# Hydrogeology of the Thousand Springs to Malad Reach of the Enhanced Snake Plain Aquifer Model

Dale R. Ralston PhD PE PG  
Ralston Hydrologic Services, Inc.  
October 28, 2008

Model calibrated transmissivity values are shown below

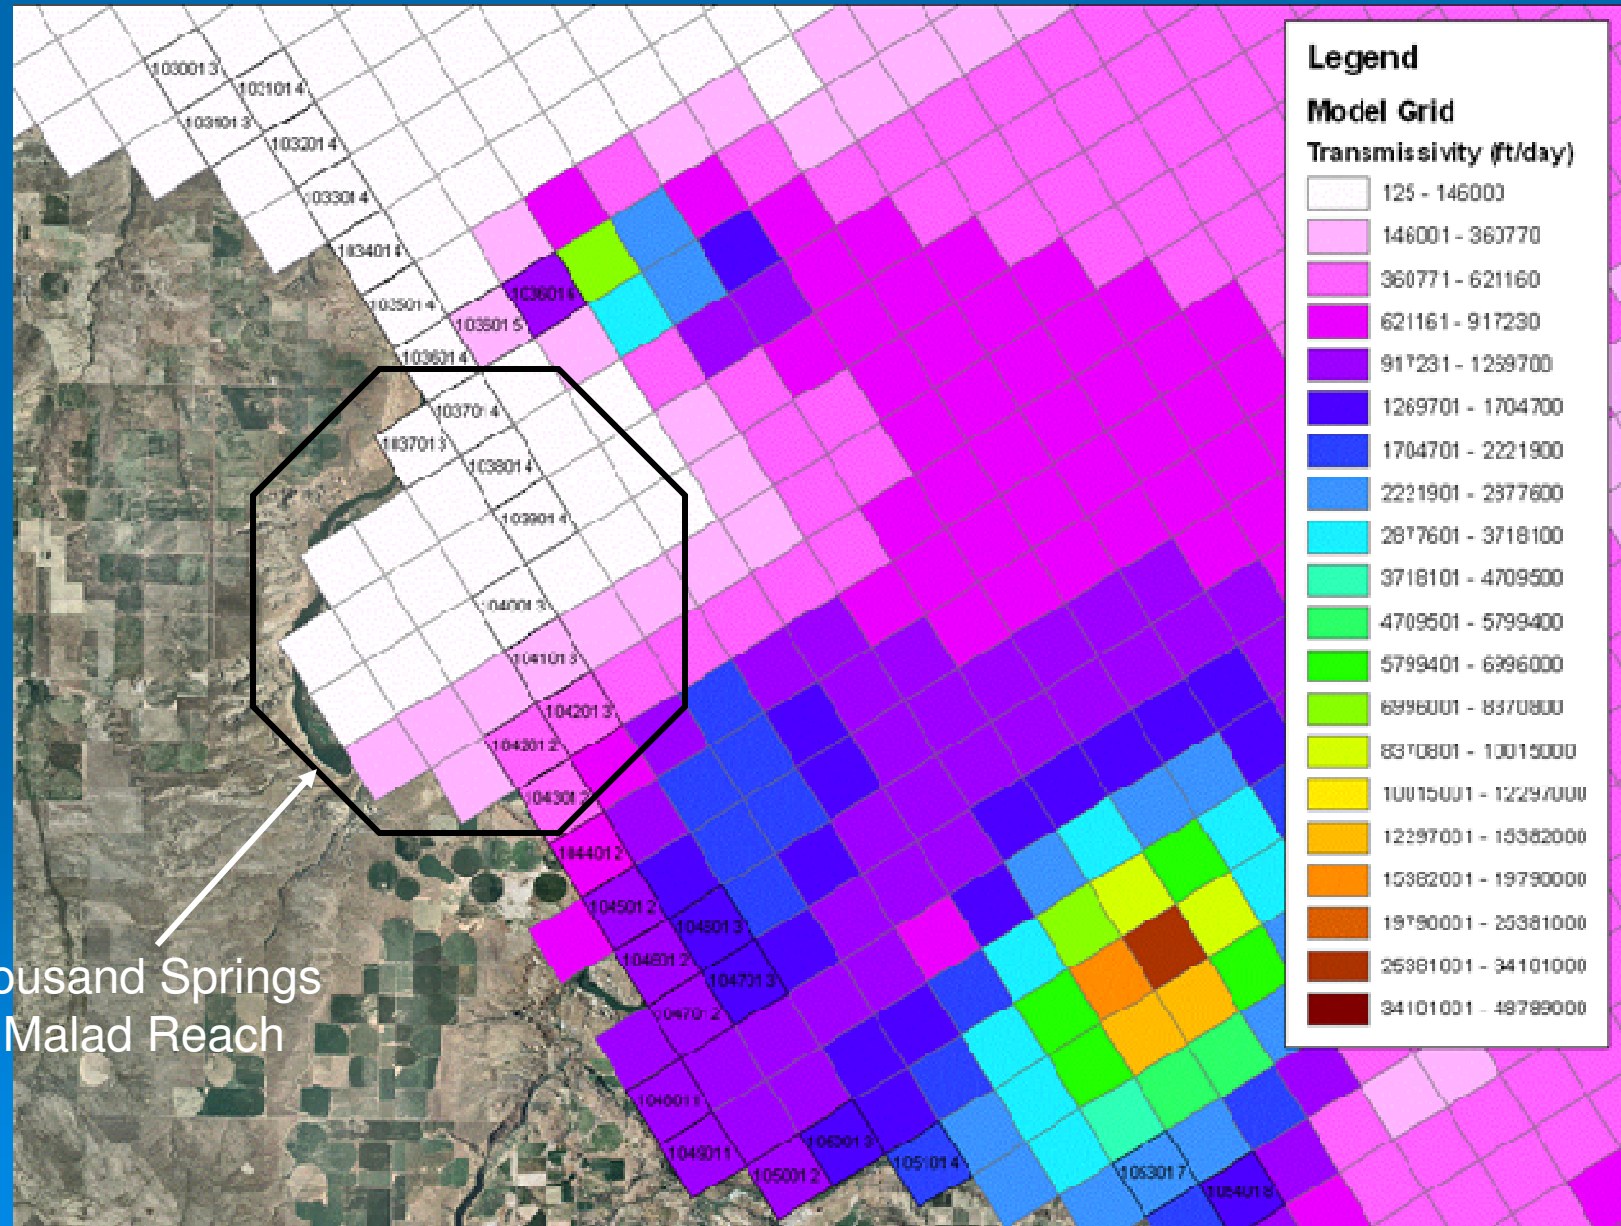
- 2. The transmissivity of the Snake Plain aquifer likely is very low along the plateau rim in the Thousand Springs to Malad reach because the saturated thickness is small (difference between the water level and the bottom of the Quaternary basalt). The model representation of transmissivity reasonably fits with this hydrogeologic conceptual model.

Location Map for the  
Thousand Springs to  
Malad Reach of the  
Snake River

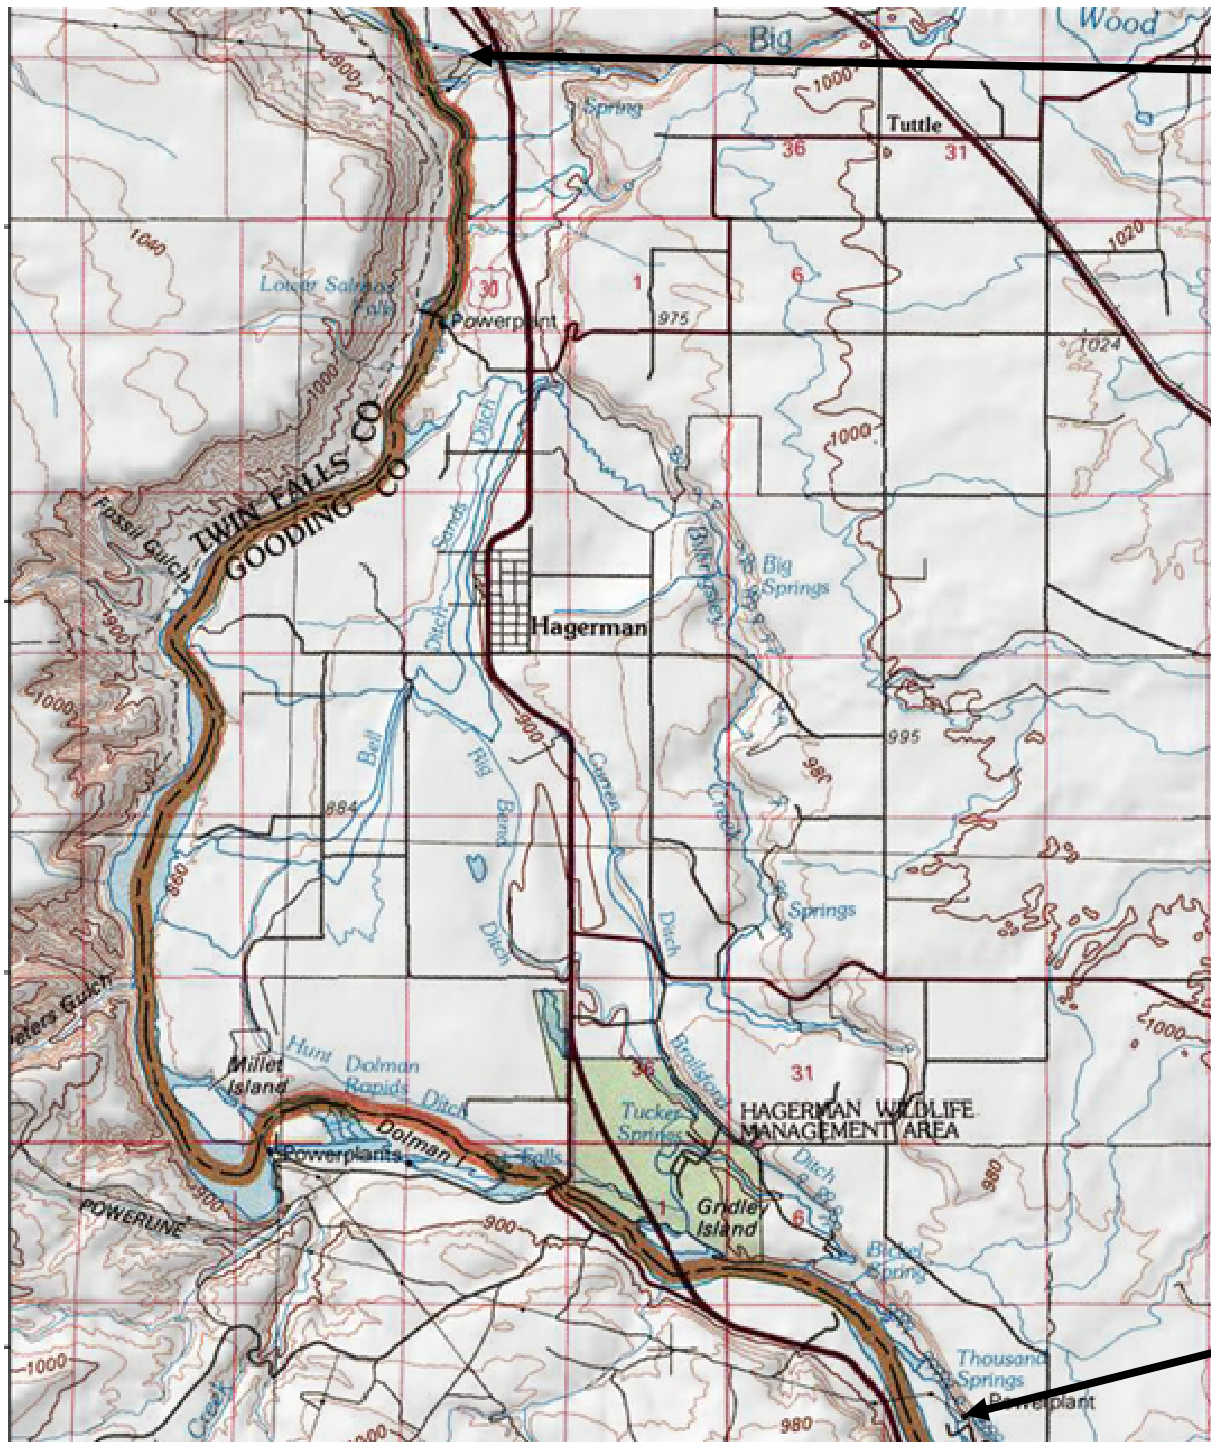
- 1. The ESPAM includes the general Hagerman area between the plateau rim and the Snake River in the Thousand Springs to Malad reach. This area should be excluded from the model because the Snake Plain aquifer is not present in this area.
